DEDHAM-WESTWOOD WATER DISTRICT

DESIGN & CONSTRUCTION SERVICES FOR A NEW VEHICULAR STORAGE FACILITY

ADDENDUM NO. 1

**TOPOGRAPHIC PLAN OF LAND
 50 ELM STREET
 DEDHAM, MASSACHUSETTS
 (NORFOLK COUNTY)**

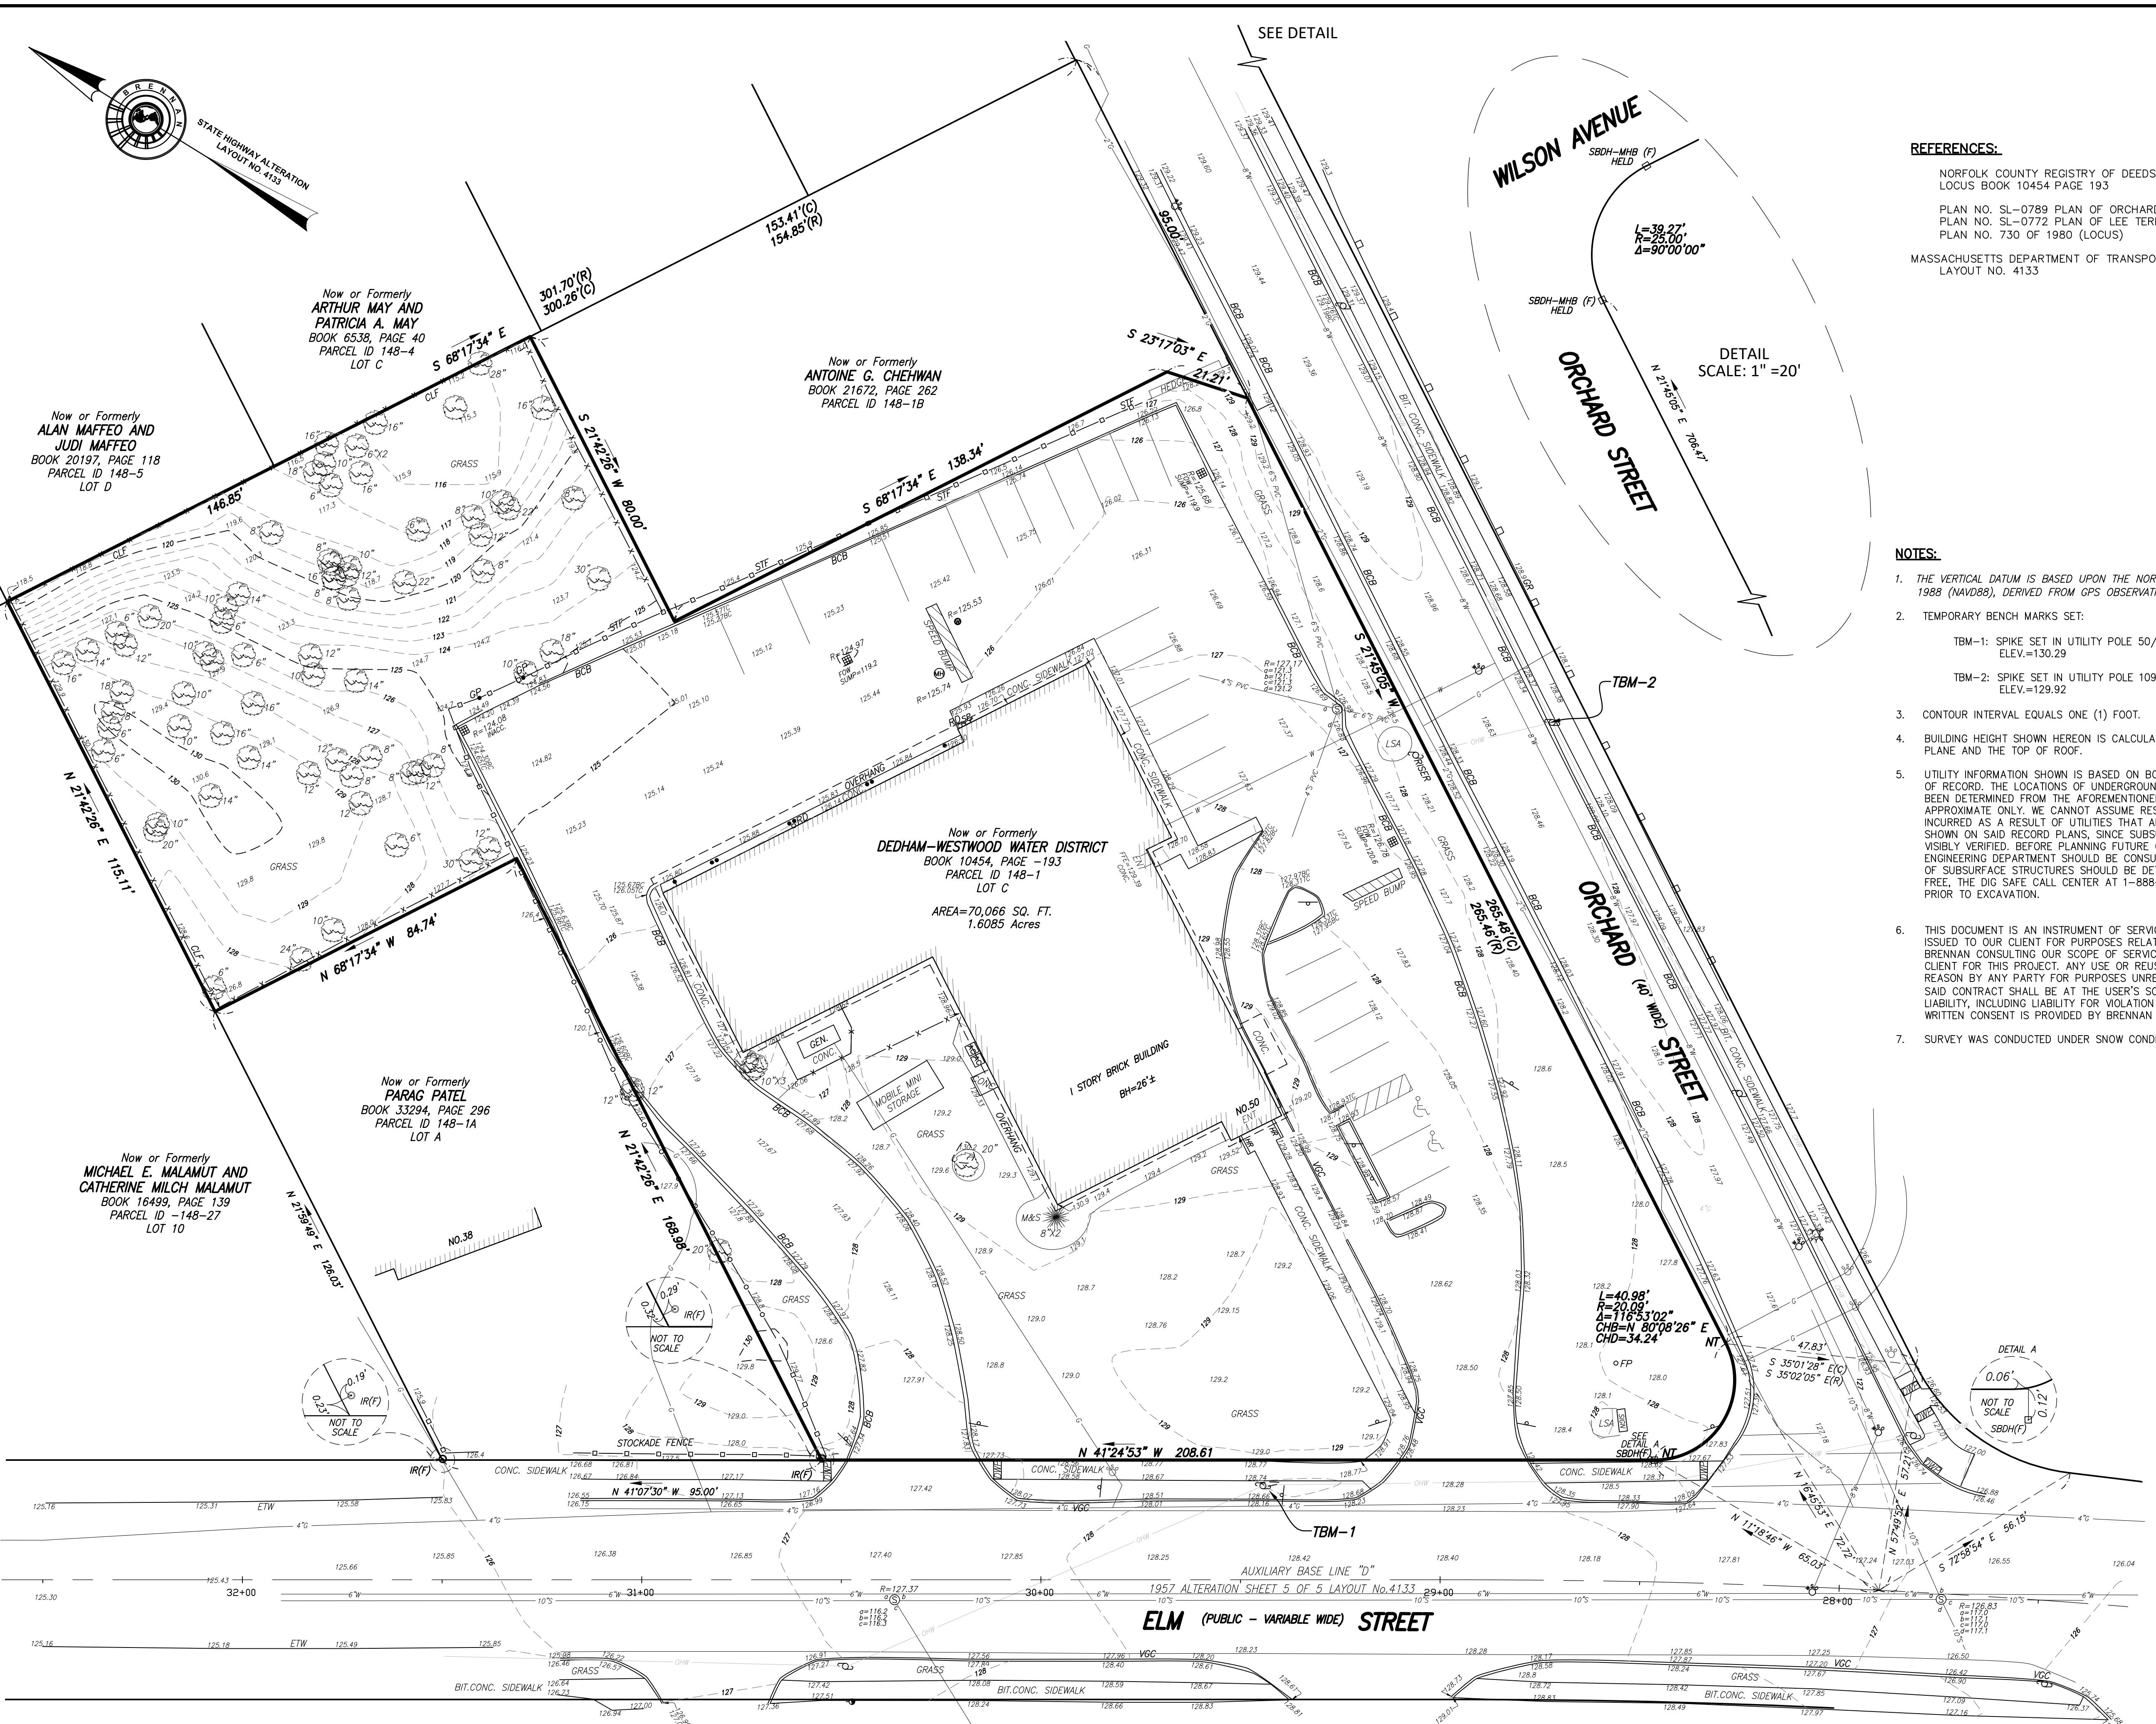
Q9: Has a survey been done for the site and if so, are the plans available in hard copy and in ACAD?

A9: Yes, a survey has been completed and is included within page 3 of this Addendum.

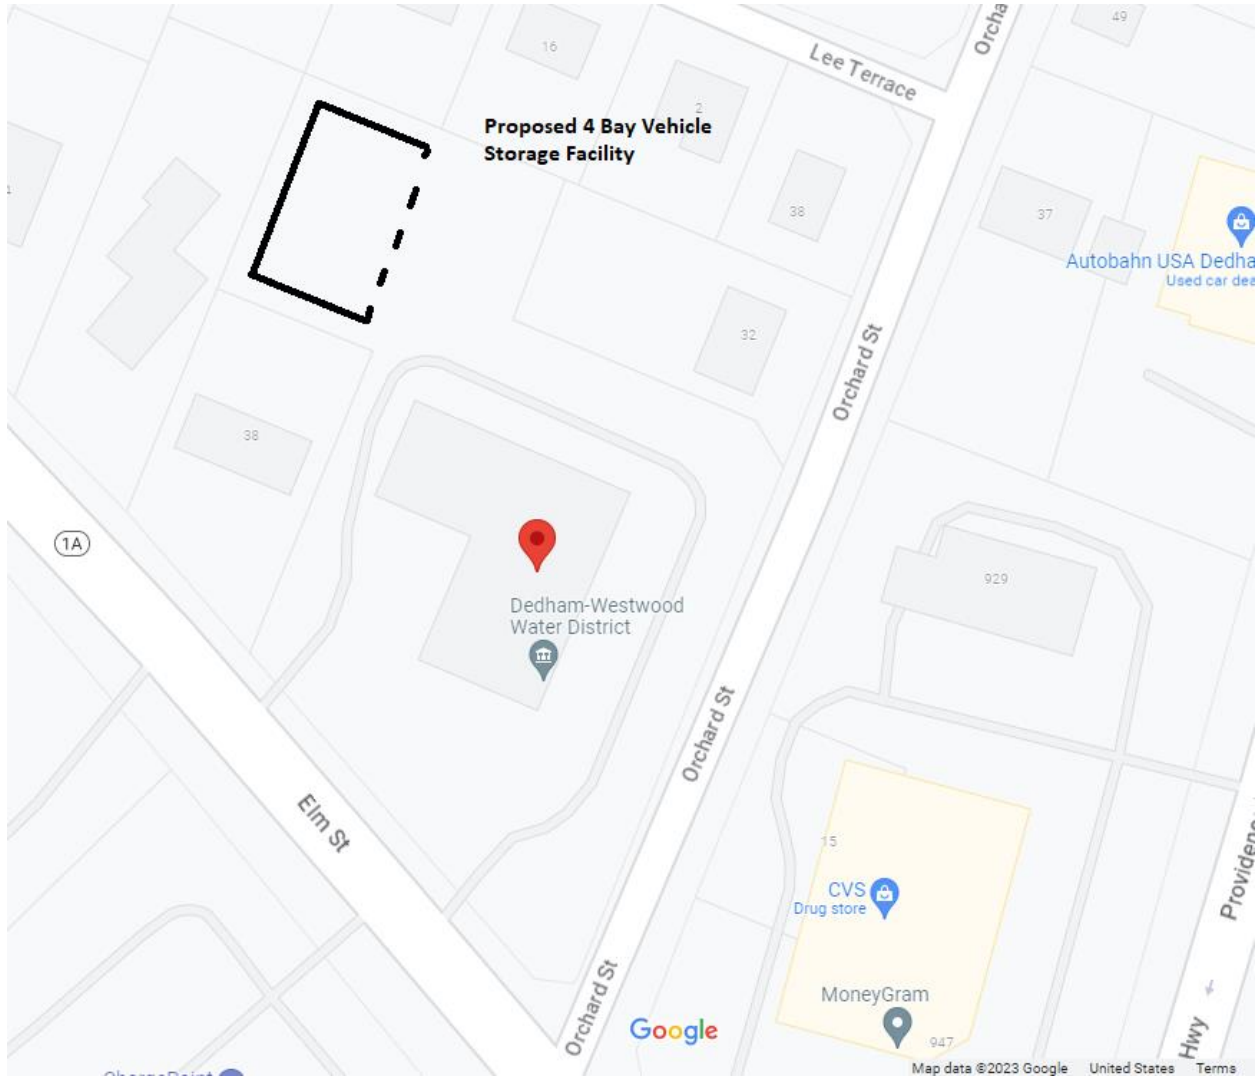
Q2: Can you provide a locus map with an outline of the proposed area and proposed building orientation?

Q12: Are there any conceptual plans, even in just rough sketch form, for what you are looking for regarding the building, fencing, etc.?

A2: Included on Page 4 of this Addendum is a locus map showing the approximate location and orientation of the proposed facility.

A12: The sketch included on page 4 of this addendum shows the location of the proposed building. The referenced sketch also shows the driveway for the facility which is a one-way from the East entrance around the building and all traffic exits on the west side. The DWWD is interested in creating a driveway across the front of the building, with parking, to allow traffic flow for visitors to enter and exit without having to drive behind the existing building. The fencing would then include a sliding gate on both the East and West portions of the driveway that travels behind the existing facility on both sides to further prevent unauthorized vehicles from driving around the back of the building.
